# H TECHNICAL BULLETIN

No: TRAILER AUS-021

Subject: Shock Absorber Improvement

Date: June 2002 Revision: A

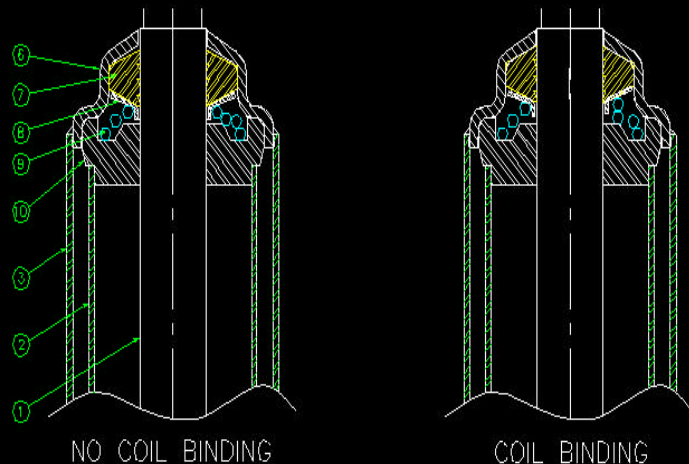
A new packing spring design was implemented effective immediately, which prevents coil binding and extra pressure being applied to the seal seat. This in some instances the extra pressure being applied to the seal and piston rod resulted in any lubricant being completely wiped away.

With little or no lubricant, the seal was run dry and prematurely failed.

This in some instances also caused the metal cap to be distorted and to come in contact with the piston rod.

This contact resulted in the rod being scored and causing the seal to fail prematurely.

All stocks of the previous version have been withdrawn and the updated shock absorber is now standard fitment in all production.
